**Re: Queen Esther Lake Dam, PADEP ID #D08-070  
Athens Township, Bradford County, Pennsylvania**

Enclosed please find one hard copy and one electronic copy of "Queen Esther Lake Dam (Dam Permit #D08-070) 2021 Inspection Report". A summary of our findings for the dam is presented below:

**DAM INSPECTION CHECKLIST**  
**Department of Environmental Protection**  
**Bureau of Waterways Engineering**  
**Division of Dam Safety**

**NAME OF DAM:** Queen Esther Lake Dam **DEP DAM NO.:** D08-070

5. View of the downstream slope from the left abutment. Note the tall grass.

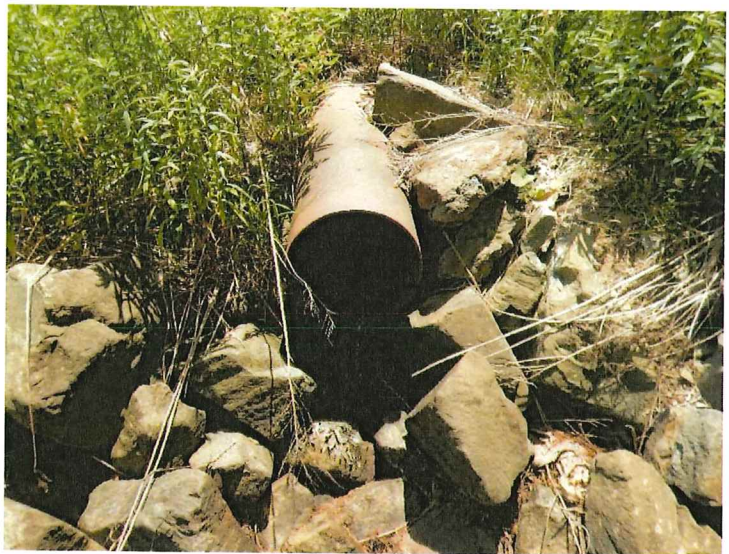
Additional Comments (Refer to item number if applicable): Item 25 – Tall vegetation on slopes promote animal burrowing and make visual inspection difficult. It is recommended that all vegetation be maintained to 12 inches or less.

11. View of the inlet of the auxiliary spillway channel. Note the cattails at the inlet.

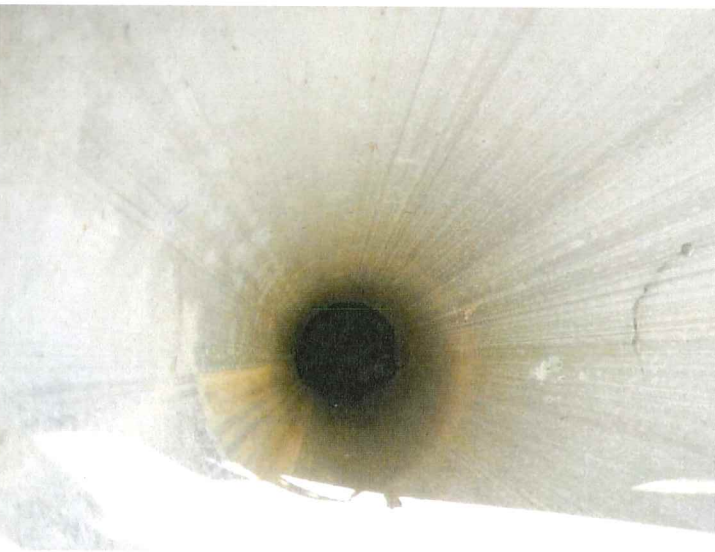
<p>Additional Comments (Refer to item number if applicable): Item 57/61 Grouted rip rap recently repaired with fresh grouting. Item 59 – Tall vegetation on dams promotes animal burrowing. Remove the cattails at the inlet of the auxiliary spillway.</p>					
<b>SPILLWAYS: DROP INLET</b>					
65	Intake Structure	8-in-diameter smooth steel pipe	<input type="checkbox"/>	<input type="checkbox"/>	<input type="checkbox"/>
66	Trash rack	None	<input type="checkbox"/>	<input type="checkbox"/>	<input type="checkbox"/>
67			<input type="checkbox"/>	<input type="checkbox"/>	<input type="checkbox"/>
68			<input type="checkbox"/>	<input type="checkbox"/>	<input type="checkbox"/>
69			<input type="checkbox"/>	<input type="checkbox"/>	<input type="checkbox"/>
<p>Additional Comments (Refer to item number if applicable):</p>
